**Subject: Palo Verde Nuclear Generating Station (PVNGS)
Unit 2
Docket No. STN 50-529
Supplement to Proposed Amendment to
Technical Specification (TS) Section 3/4.9.6,
"Refueling Machine," Under Emergency Circumstances**

**NRC QUESTIONS AND APS RESPONSES RELATED TO
PROPOSED AMENDMENT TO TECHNICAL SPECIFICATION
SECTION 3/4.9.6 "REFUELING MACHINE"
UNDER EMERGENCY CIRCUMSTANCES**

CONCEPTUAL
FUEL BUNDLE STRAP ASSEMBLY
STRAP SCHEME
QUESTION 1

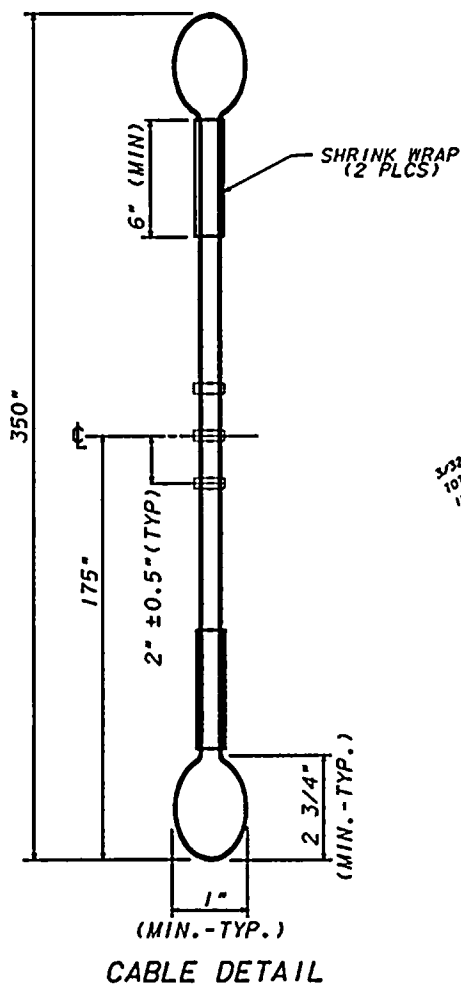
1. How will the structural integrity of the fuel assembly at location A-07 be assured during movement?

Structural integrity of the fuel assembly will be assured by installing external reinforcement using one of the following two methods:

The first method of reinforcement is the use of two separate 1 inch wide stainless steel straps installed on opposite sides of the assembly. The straps will be attached by clips to a steel jacking plate, installed on the upper plate at the top of the assembly, and to the web of the assembly's lower end fitting (LEF) (See Figure 1). The jacking plate will have adjusting bolts that would press against another steel plate underneath (the bearing plate) and thus pull up on, and tension, the straps. The straps will be tensioned enough to take up the slack, but not enough to compress the fuel assembly.

CONCEPTUAL
TEMPORARY LIFT RIG
REF: QUESTION #2
FIGURE 3

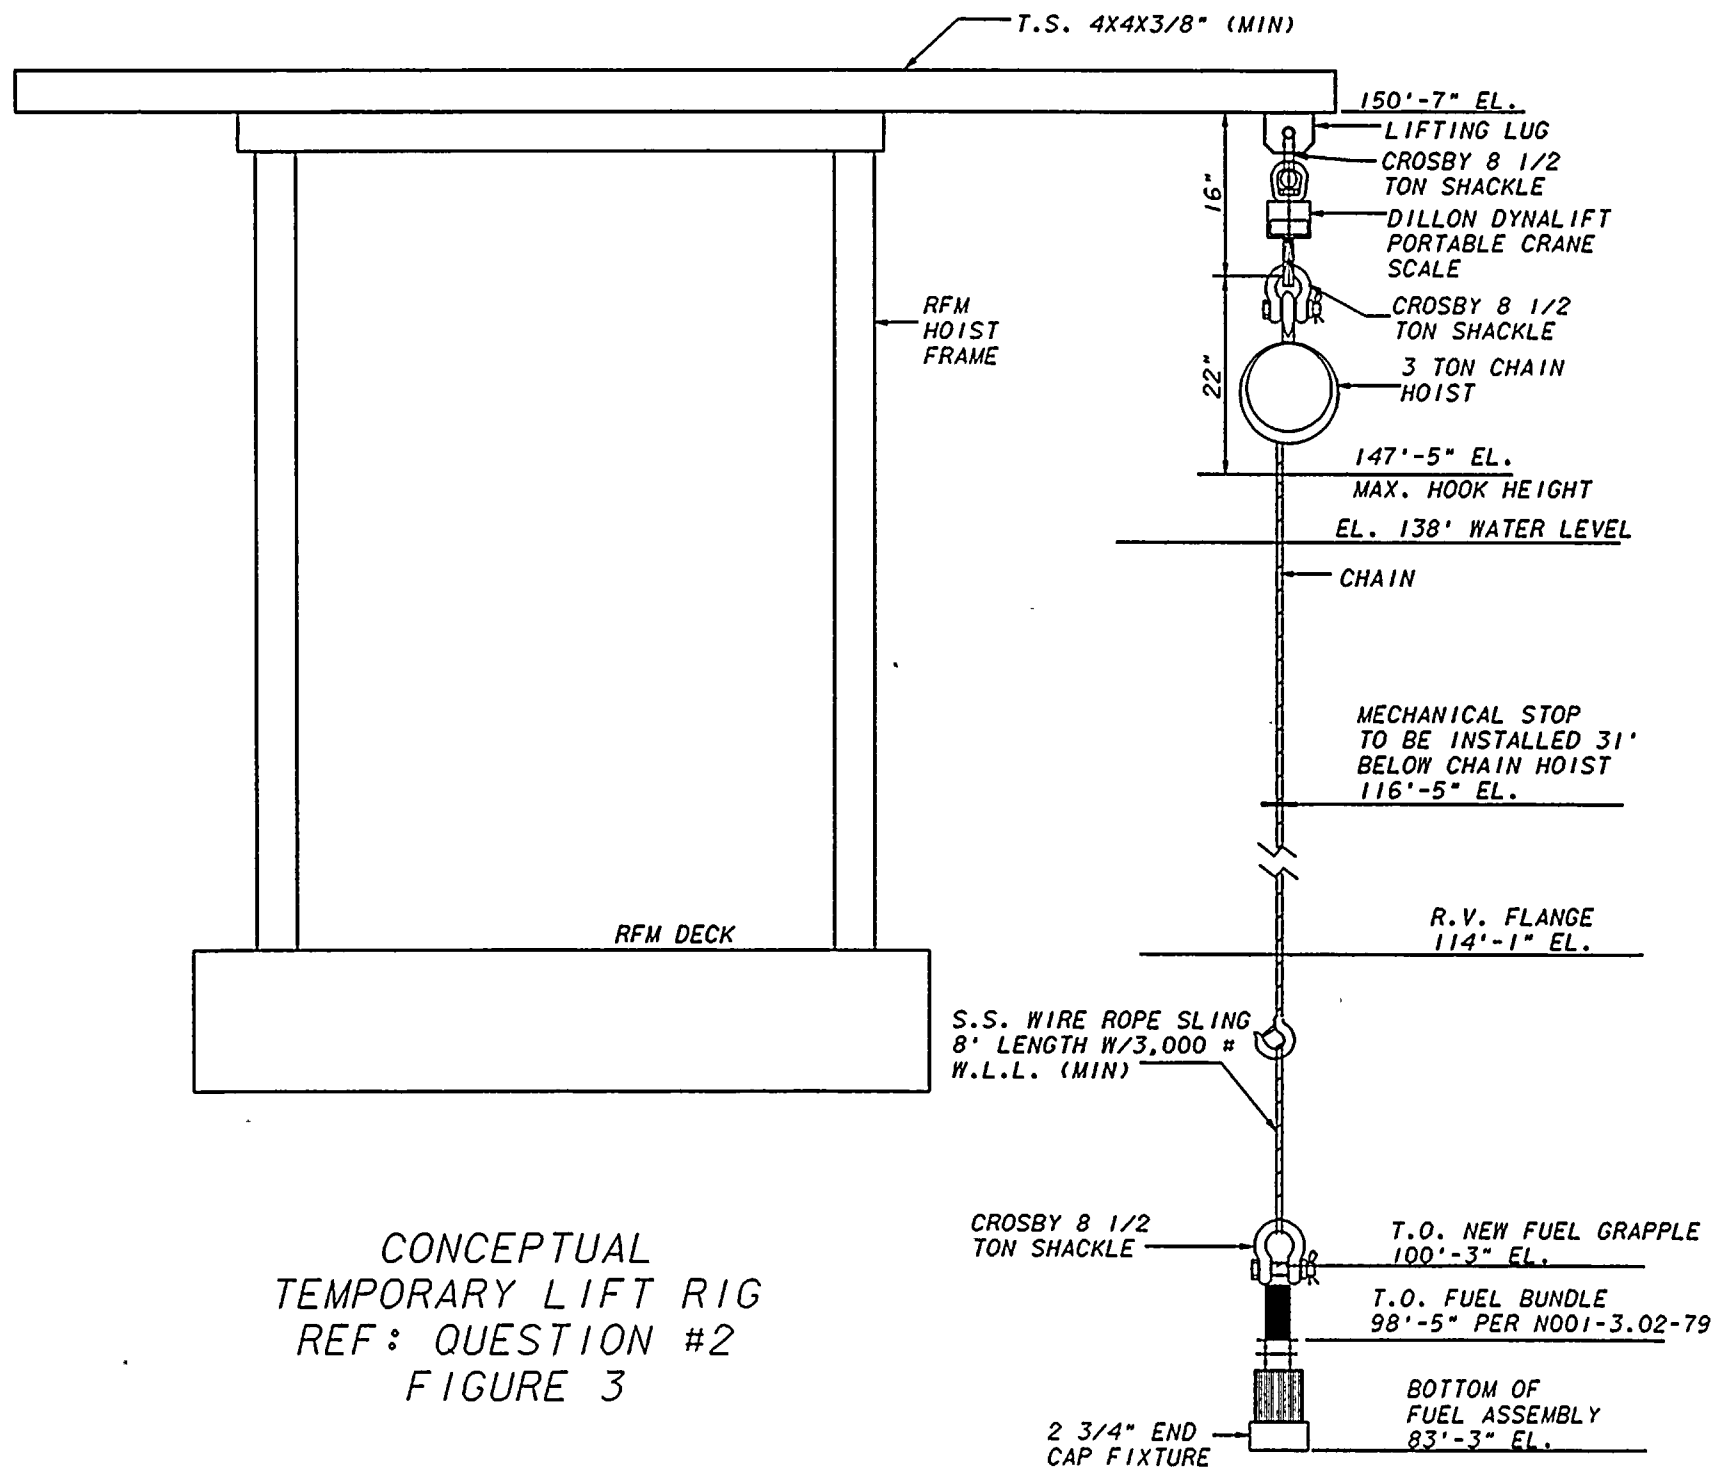
2. Describe how the temporary hoist will be attached to the refueling machine.

The temporary lift rig will consist of the following:

- An 8 foot, 4 inch long, 4 inch square steel tube will run across the top of the refueling bridge hoist frame rails. The tube will be attached to the hoist frame rails by two 1/2 inch U-bolts and a 3/4 inch steel plate at each rail. The beam will extend 41 inches

past one side of the refueling machine frame rail. A lug will be welded to the underside of the beam such that the load cell/hoist assembly will hang at a position 36 inches past the frame rail. The beam has a design capacity of at least 3000 pounds, which is approximately 1.5 times the maximum expected load.

- A load cell (with a capacity of 5000 pounds) will be hung from the lug, welded to the underside of the beam at the end, extending past the refueling machine.
- A hoist will be hung from the load cell.
- The new-fuel grapple hung from the hoist.

A drawing is attached that shows the temporary lift rig attachment (See Figure 3).
